4156C-04

# <u>SERVICE NOTE</u>

# 4156C Semiconductor Parameter Analyzer

**LCD Picture Intermittently Reverses or is not Displayed**

Front panel assembly

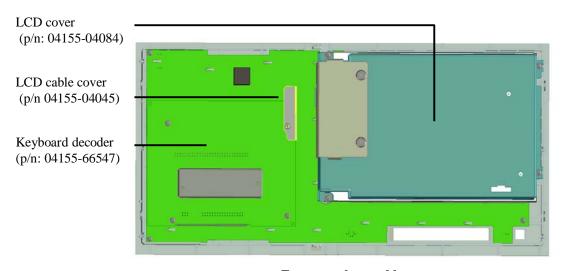
The 4156C within the listed serial number range may have the problem that the LCD picture intermittently reverses or is not displayed. The cause of the problem is that the PC board stresses the LCD cable, and the cable connection becomes loose.

When the 4156C is sent to Agilent service center for a repair, check if the LCD cable is securely connected, and add the LCD cable cover (p/n 04155-04045) to prevent the stress from the PC board.

After the LCD cable cover is installed, execute the display diagnostics to check the LCD functionality.
